Access Compliance Report

Public Rights-of-Way

(Pedestrian Signals)

Intersection ID: N/A	Main Street:	Cross Street: N/A	Location: N/A
ADA ID: E74AF1E1C592	Signal Type: One Push Button-Non APS	Overall Compliance: No	Severity Score: BTN 1: N/A BTN 2: N/A No BTN: N/A
Codes/Mitigation Info/Possible Solution		Field Measurements/Component Compliance

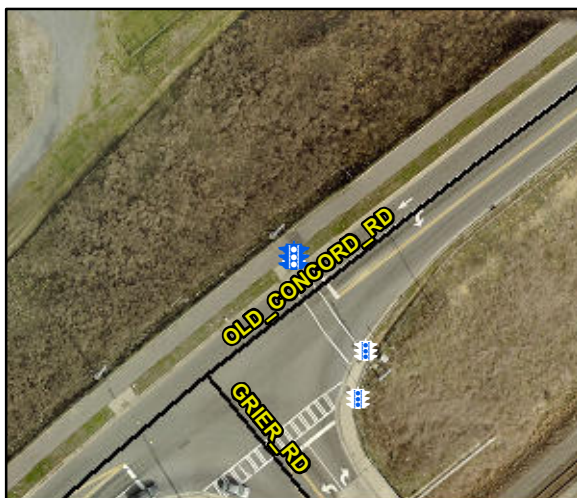
Surveyor Notes: TEXT HT 7/16

PROW/ADA: R410.6, R404.2, R404.3, R406.2

Possible Solutions: Remove & Replace Sign. Provide Push Button Extension. Remove and Replace Clear Space.
